O'FALLON AND O'FALLON FIRST ADDITION **SUBDIVISION**

APPLICATION NUMBER 6 DATE November 7, 2013

DETAIL SITE PLAN

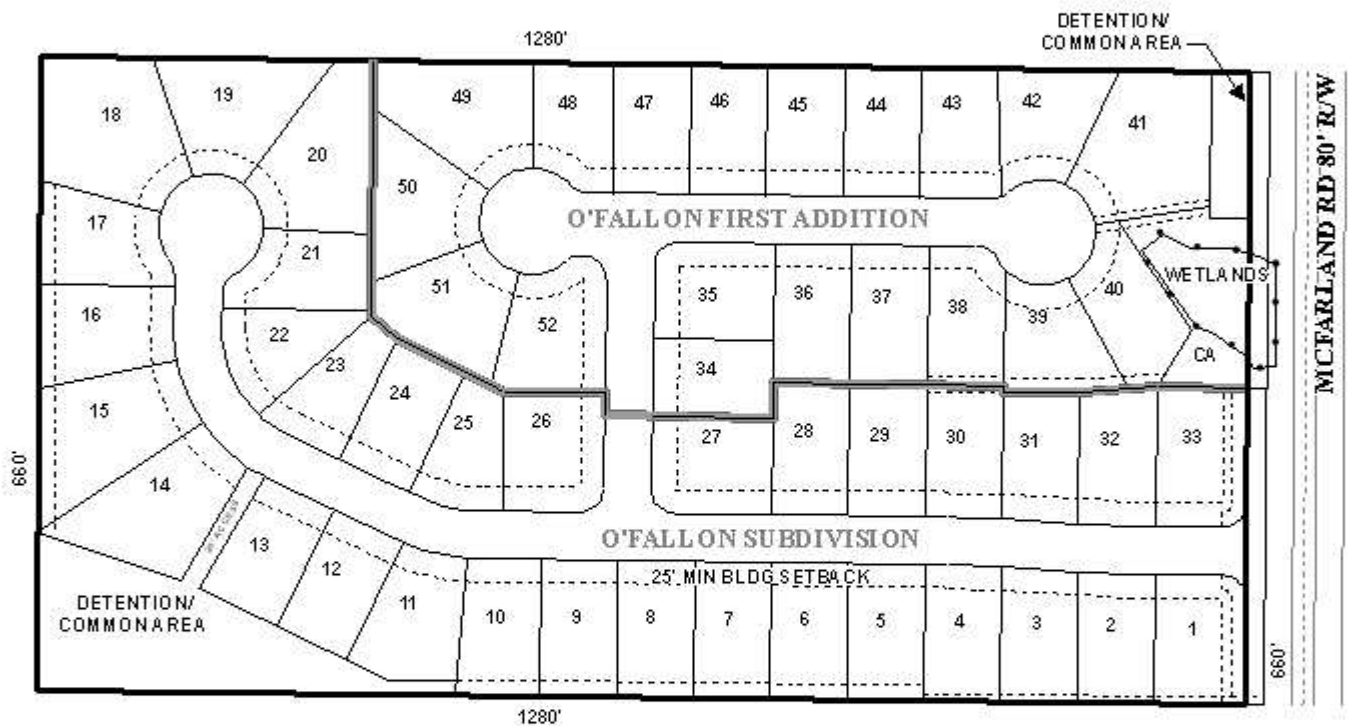
Although it does appear that all lots meet minimum size requirements any lots less than 7,200 square feet must be resized to comply with the Subdivision Regulations. Lot sizes for are not labeled on the preliminary plat. Labeling of the lot area size, in square feet, or provision of a table on the Final Plat with the same information will be required if approved.

The site fronts McFarland Road which is shown as a major street on the Major Street Plan component of the Comprehensive Plan. The preliminary plat submitted indicates that McFarland Road has a current 80' right-of-way; however, a minimum of 120' right of way is required by the Major Street Plan. Therefore, dedication of sufficient right of way along McFarland Road to provide 60' from centerline will be required.

Access management is a concern thus; a note should be placed on the plat stating that all lots and common areas fronting McFarland Road are denied access to McFarland Road. A note on the

final plat should be modified to state that each lot and detention/ common area access is limited to one curb-cut, with the size, design and location to be approved by Mobile County Engineering.

Development of the site will require the construction of new streets. All roads must be built to County standards and accepted by the County, prior to the recording of the Final Plat. Furthermore, the location of the proposed 20-foot wall as depicted on the plat will be subject to the approval of County Engineering.

The site has closed-end streets that exceed 600 feet. Thus, a waiver of Section V.B.6 of the Subdivision Regulations shall be required. According to the design standards and right-of-way widths located in the Subdivision Regulations a closed-end street must have a turnaround right-of-way diameter of 120 feet, however, the plat only reflects a diameter of 110 feet. The cul-de-sac diameter should be revised to comply with Section V.B.14. of the Subdivision Regulations, and revised lot sizes shall be required for any lots that abut each cul-de-sac.

The site has property lines at an intersection corner. Section V.D.6. of the Subdivision Regulations requires that *“property lines at street intersection corners shall be arcs having radii of at least 10 feet or shall be chords of such arcs.”* The curb radii is depicted on the preliminary plat, and if approved should be depicted on the final plat as well.

Three common areas are depicted on the preliminary plat. There is also a 20-foot wall and landscaping easement illustrated at the entrance to the subdivision. A note should be placed on the final plat, if approved, stating that maintenance of the common areas and the 20-foot wall and landscaping easement is the responsibility of the subdivision’s property owners.

The 25-foot minimum building setback is shown on the plat, and should be placed on the Final Plat, if approved. Revisions along McFarland Road due to dedication should be made and the illustration of the new 25-foot minimum building setback line should be depicted.

There are several drainage easements located on the site that lead to the common area and retention/ detention ponds. A note should be placed on the final plat stating that no structures shall be constructed or placed within any easements.

It should be noted that the site plan depicts limits of wetlands on the site which may indicate that the area is environmentally sensitive; therefore, the approval of all applicable federal, state and local agencies will be required for wetland issues.

There appear to be errors in the notes and site data table in regards to the total number of lots and lots that are denied direct access to McFarland Road. Revisions to the notes should be made to reflect what the plat depicts. Also, McFarland Road is listed as McFarland Drive on the preliminary plat. Revisions should be made to the plat to illustrate the correct street name.

It should be noted that item number three in the "SITE DATA" table located on the preliminary plat indicates that there are a total of 33 lots instead of the 52 that appear on the plat. Also, within the "Notes" section of the plat the actual lot numbers that are denied direct access to McFarland Road appear to be incorrect. Furthermore, the plat illustrates there are some wetlands on the site, thus a note should be provided addressing wetland issues.

1. revisions to the site plan to depict dedication of sufficient right of way along McFarland Road to provide 60' from centerline;
2. revisions to the site plan to depict a turnaround right-of-way diameter of 120 feet;
3. revised calculations of lot sizes where the property abuts each cul-de-sac;
4. revision of all lot size calculations to reflect any modifications required due to right-of-way dedication or cul-de-sac changes, and labeling of all lots with their size in square feet; and
5. revise plat to illustrate the correct labeling for McFarland Road.

- 1) revise site data table on the plat to reflect the correct number of total lots;
- 2) revise notes on the plat to reflect the correct lot numbers that are denied direct access to McFarland Road;
- 3) compliance with Engineering comments: "Must comply with the Mobile County Flood Damage Prevention Ordinance. Development shall be designed to comply with the storm water detention and drainage facility requirements of the City of Mobile storm water and
